Campaign - Charge Air Cooler Inlet Duct Detachment

Bulletin No.: 09126

Subject: 09126 - Service Update for Inventory and Customer Vehicles - Charge Air Cooler Inlet Duct Detachment - Expires with Base Warranty

2008-2009 Chevrolet Cobalt SS, HHR SS
Equipped with a Manual Transmission

First Design Stud

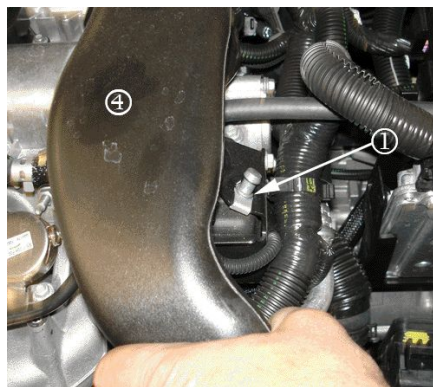
This bulletin provides a service procedure to install a new stud and retainer on **certain** 2008-2009 model year Chevrolet Cobalt SS and HHR SS vehicles equipped with a manual transmission. On these vehicles, the charge air cooler inlet duct may become detached and contact the high pressure fuel pump connector. This contact could eventually cause damage to the connector, causing the fuel pump to become inoperative. If this were to happen, the Engine Power Reduced message would illuminate in the DIC and the maximum vehicle speed would be reduced to 20 mph (32 km/h).

Second Design Stud

Retainer Clip

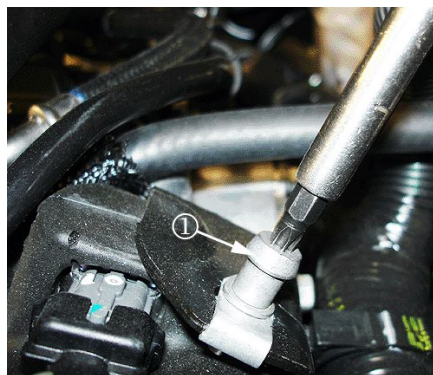
2. Locate the charge air cooler (CAC) duct (4).

3. Remove the CAC duct (4) off of the first design mounting stud (1).

4. Remove and discard the first design mounting stud (1).

5. Install the second design mounting stud (2).
